U. S. NUCLEAR REGULATORY COMMISSION  
REGION I

REPORT NOS. 50-220/92-19  
50-410/92-21

LICENSEE: Niagara Mohawk Power Corporation

FACILITY NAME: Nine Mile Point Nuclear Station Units 1&2

FIGURE 2.0 Simplified diagram for UPS control logic power supply (shown at time of event)

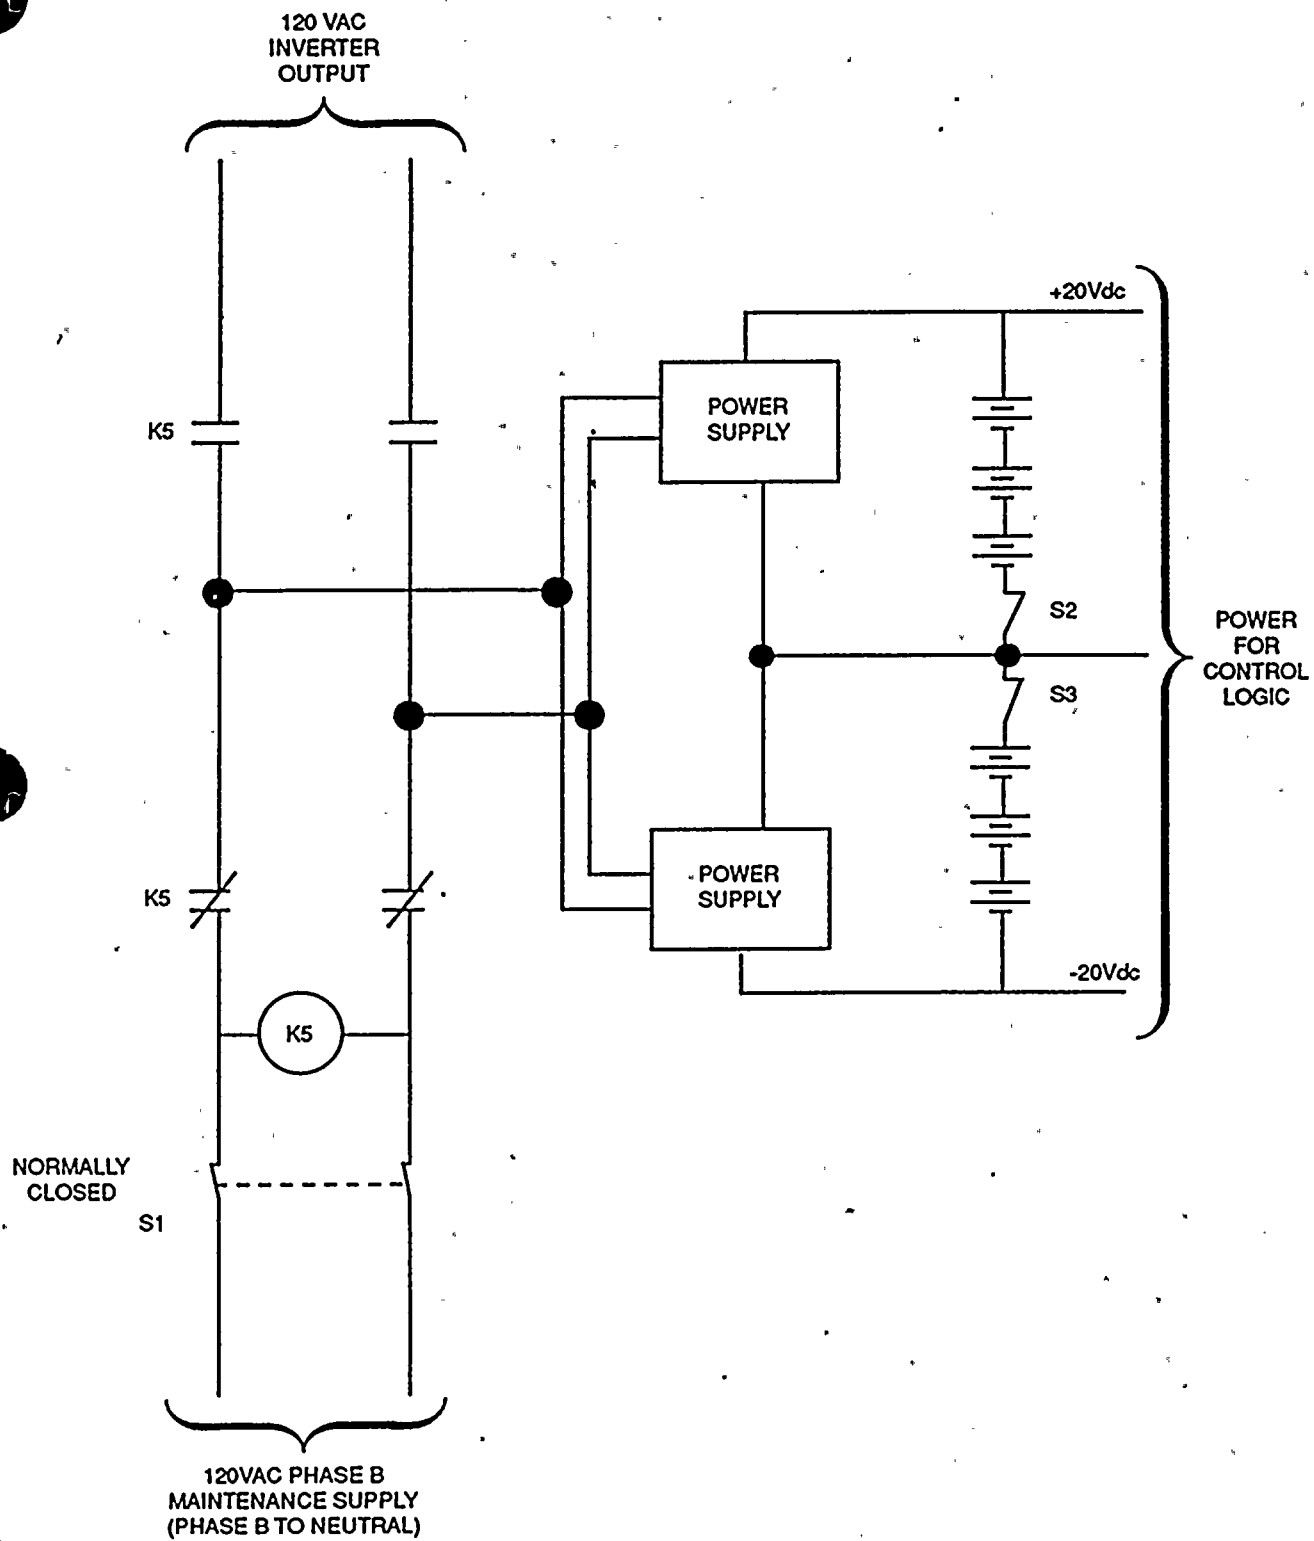
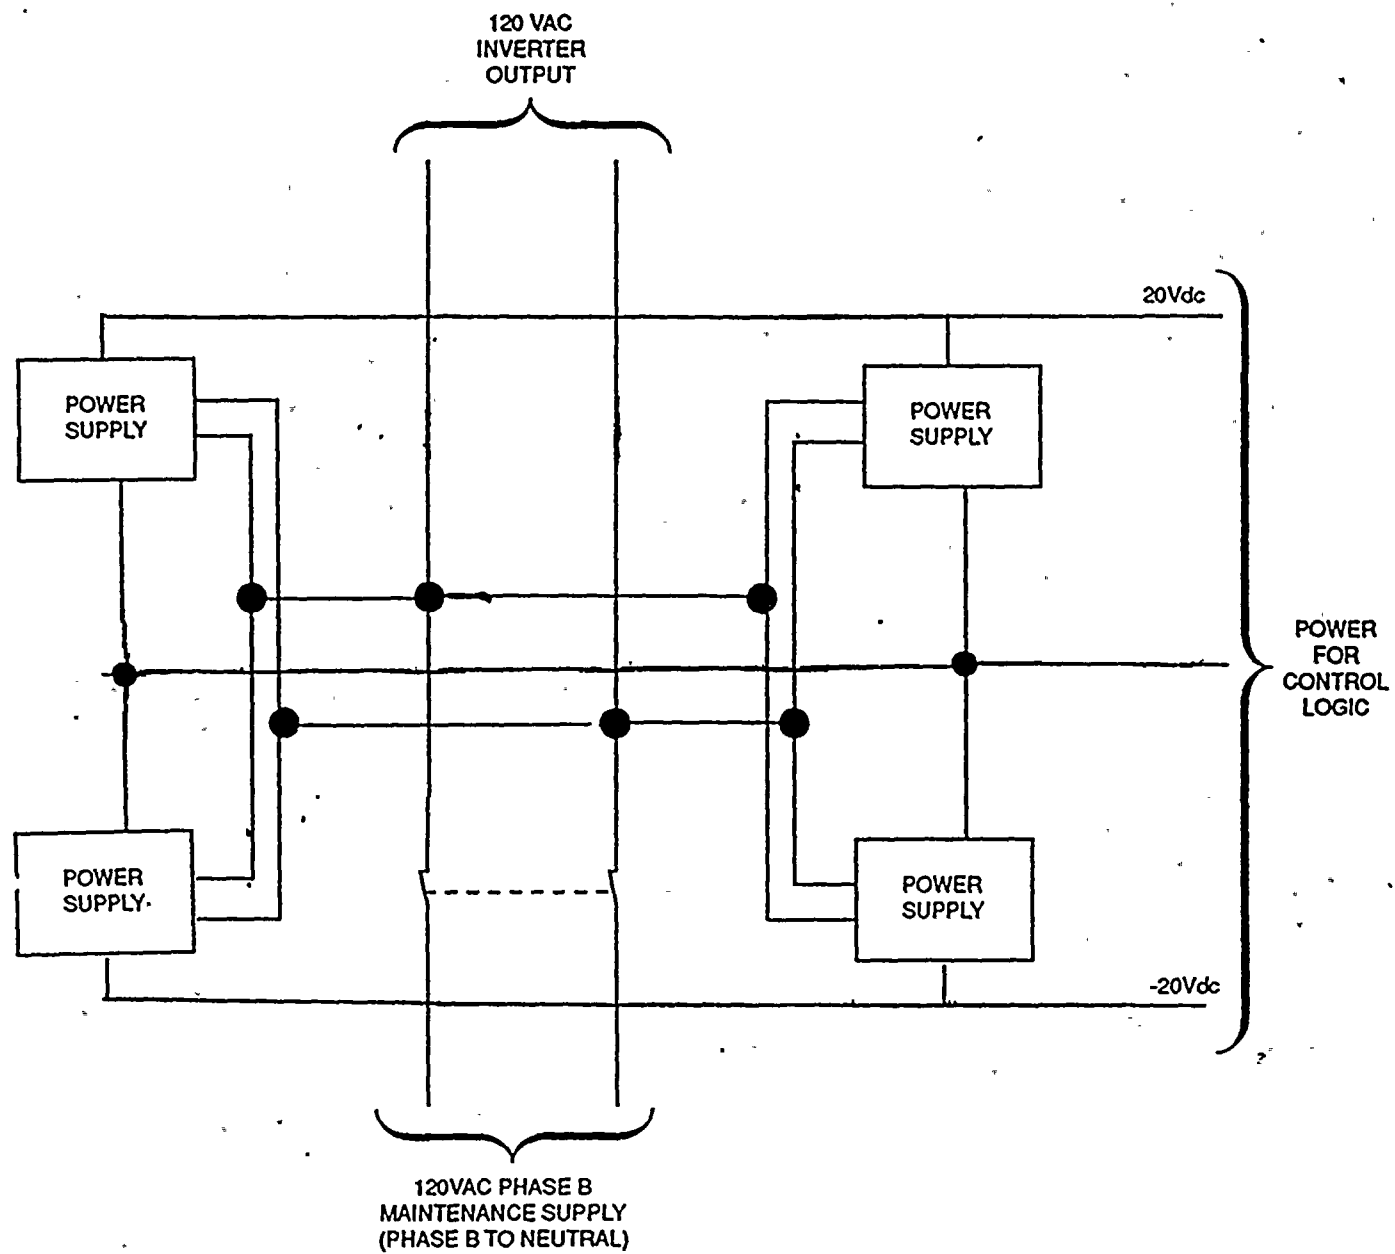
The IIT team, in Section 4.3.4 of their report, identified a concern with the UPS logic power supply. If the maintenance voltage supply degrades, this will result in a loss of the UPS. This concern, a common mode failure of all five UPS units, was confirmed on August 13, 1992, at the Nine Mile Point 2 event.

During this inspection, the inspector noted that the licensee has made additional design changes in the UPS logic power control panel to make these units more reliable and maintainable. A simple design change, SC2-0309-91, implemented by the licensee, has modified the UPS-1A, 1B and 1G UPS units. This modification replaced the existing power supply panel (A27 Pan) internal to the UPS units with an upgraded version. The old power supply panel had two internal power supplies (the maintenance and inverter power supplies). In the old design, a relay (K5) was used to switch the power from one source to another upon failure of the preferred source for the control logic, as shown in Figure 2.0.

The new power supply panel has four power supply units. In this design, each power source (preferred and alternate power source) is connected to two power supplies. There is no switching function required upon a failure of a power source. Thus, in this design, power to control logic is available at all times. Based on the more reliable power source design feature added by the licensee, the battery back-up source to the logic was deleted. The deletion of the batteries resolves the concerns of battery depletion and detection.

The inspector's review of the design documentation and as-built conditions, and walk down of equipment revealed no concerns. The design package pertaining to the above modification was found to be of good quality with sufficient details and adequate supporting documents. The changes to the instruction manual and affected procedures were adequately addressed in this design package. Several component level vendor drawings were added by the licensee as a part of this modification.

The inspector had no further questions based upon: the availability of both power sources simultaneously for the logic control circuitry for three UPS units; reduced loads on the remaining two units; routine replacement of control logic batteries; established procedures; and the replacement plan for the remaining two units by the end of 1992.
